Farnborough ACP response for MOD consideration

FINAL MOD RESPONSE TO THE REVISED FARNBOROUGH AIRSPACE CHANGE PROPOSAL (ACP)

TAG FARNBOROUGH – AIRSPACE CHANGE PROPOSAL

1.6 Close up view showing area of concern:

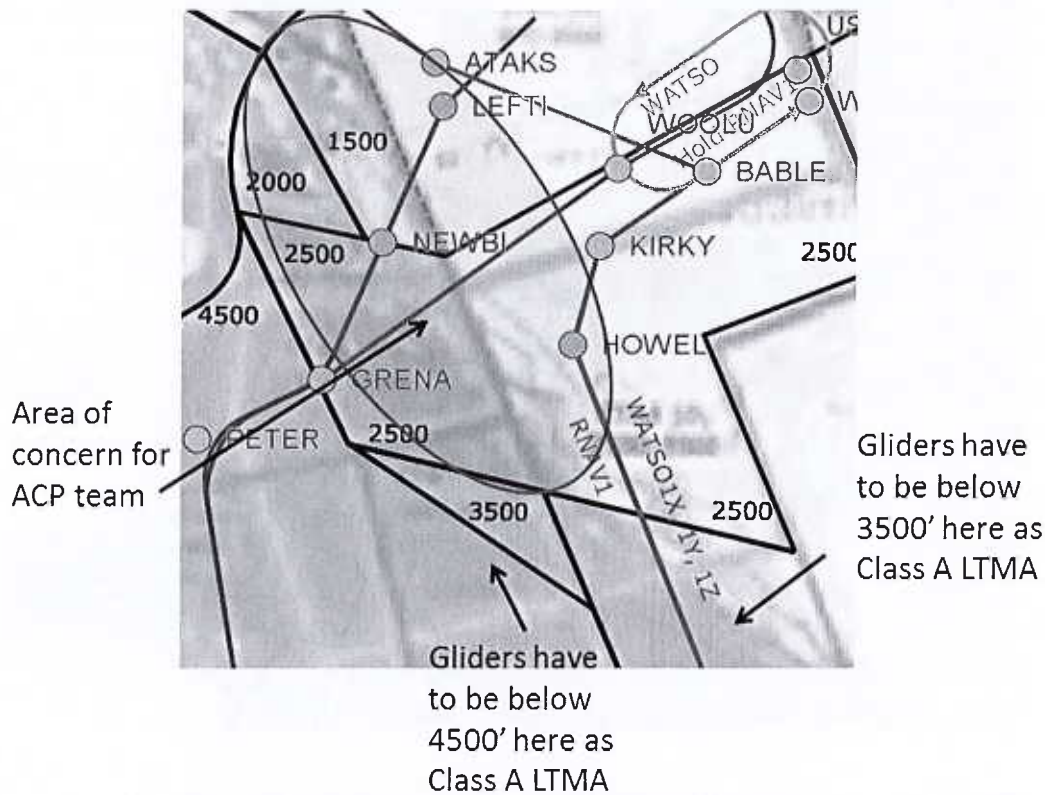
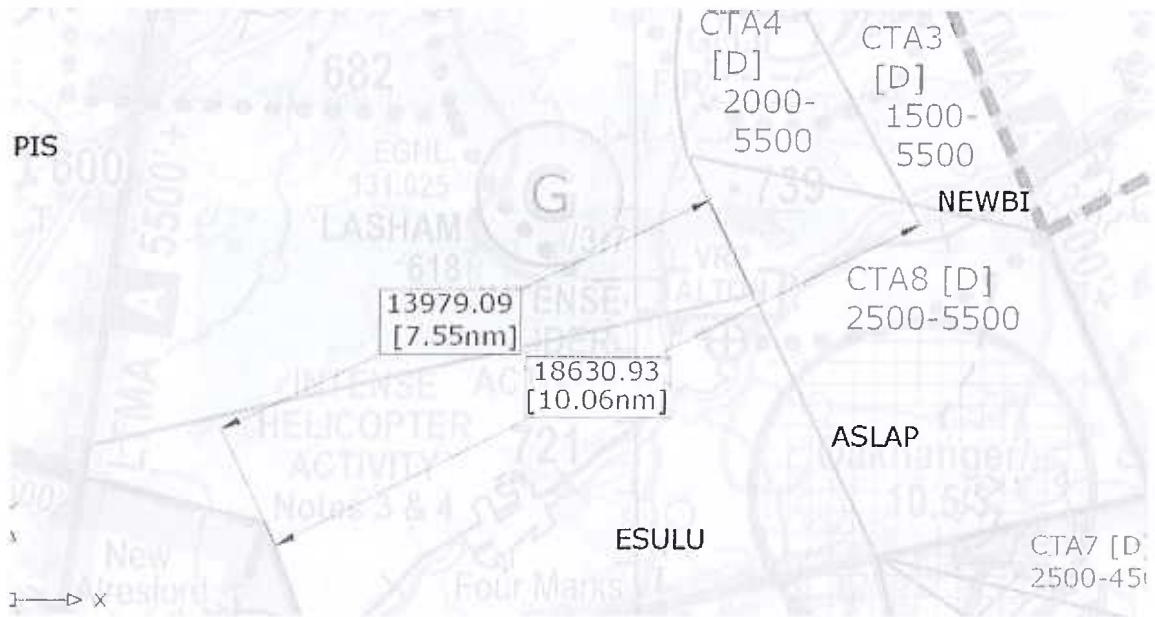
The ACP design team acknowledge that there may be a small percentage of gliders that will have to alter their flight path to avoid the GRENA area above.

The next question is 'what is the reduction in airspace that would be commonly used in the Alresford – Lasham gap?' Using the BGA information it can be shown that the cross country gliders rarely go further east than the eastern edge of CTA4 – so the current gap for gliders is 10.06nm approximately. If CTA8 +CTA4 were in place, the reduction would be 25% of useable gap, being reduced from 10nm to 7.55nm. The majority of this reduction in gap is above the VO ATZ or on final approach for R06 LF in CTA4, the use of which has the potential to severely compromise operations at both airfields.

This reduction does not equate to an increase of 25% of gliders in the 'gap'. The best estimate of the ACP team using information observed that 10% of gliders might be affected.

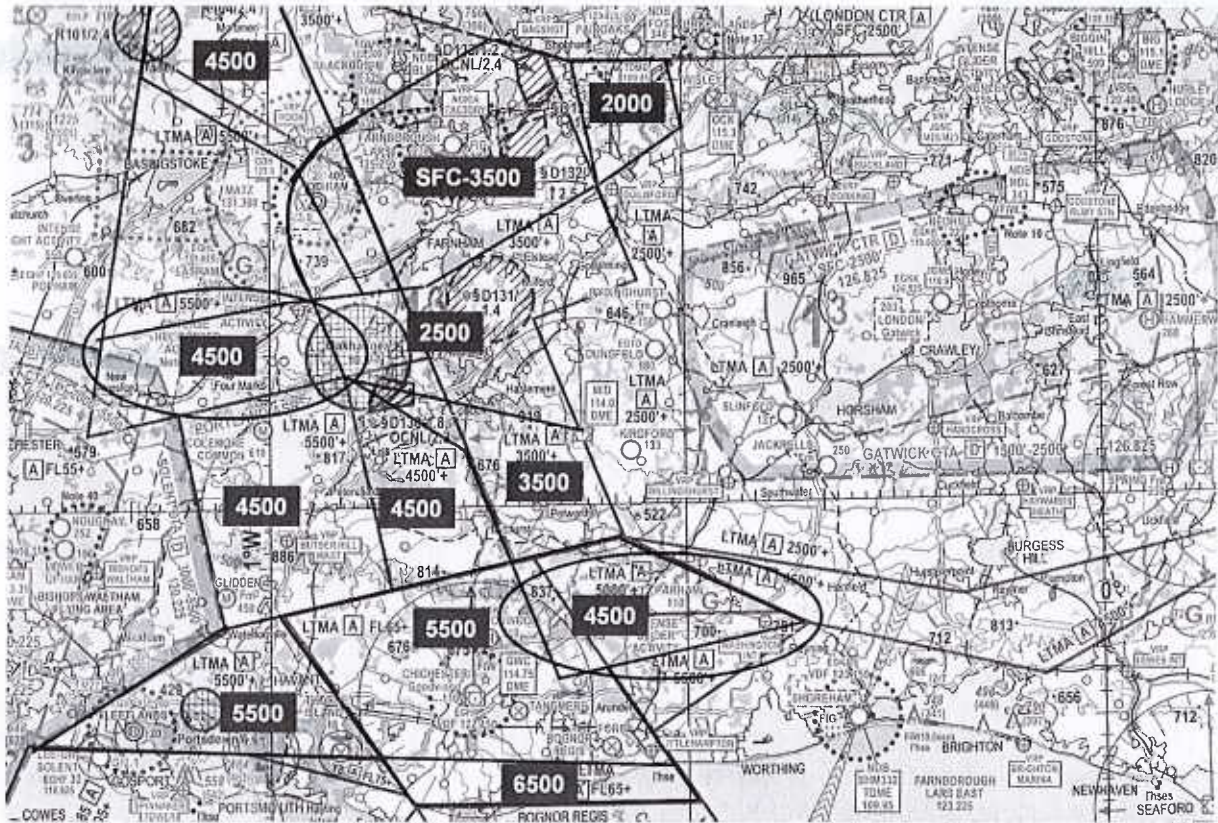
When returning from Lasham the start of the 4500' airspace is encountered about 6.5 kilometers before it was. This basically removes 6.5 kilometers from the distance we can glide on the downhill run back to Parham airfield. If this area, highlighted by the oval south of Lasham, could be looked at with a view to raising it back to 5500' or moving its Northern boundary further South, this would really help.

Secondly, a number of our less experienced (and often local soaring restricted) pilots have achieved their Silver height claims in the vicinity of Parham airfield this year. With the proposed airspace these flights would not have been possible. With this area being so far from Farnborough, it is difficult to understand why this reduction in our overhead airspace is needed.

I would ask that you take a look at these two areas (shown on the attached map) and get back to me with any suggestions for improvement.
